# Service Bulletin

### 2014 CTX700ND ABS MODULATOR REPLACEMENT

NHTSA Recall 13V-307

**PREVENTING BRAKE FLUID LEAKAGE (Step 10)**

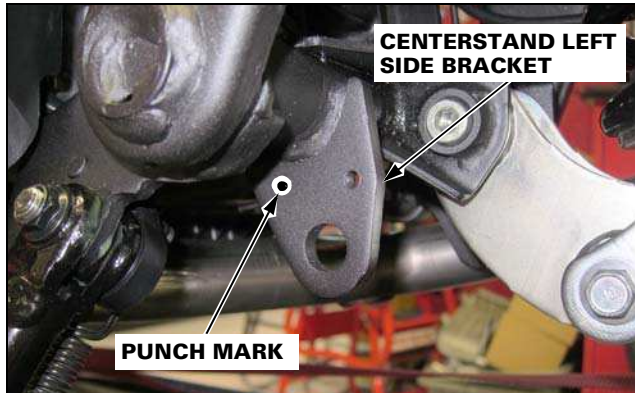
1. Connect a bleed hose to the front caliper bleed valve.
2. Loosen the bleed valve and then pull the front brake lever fully against the handlebar. Secure the lever against the handlebar with a band or zip-tie and close the bleed valve.

This will help prevent the brake fluid from leaking out of the reservoir during ABS modulator replacement.

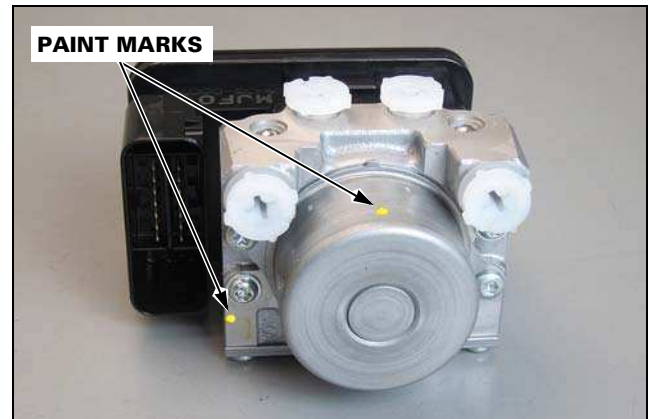
After you have completed the REPAIR PROCEDURE, make a punch mark on the centerstand left side bracket as shown.
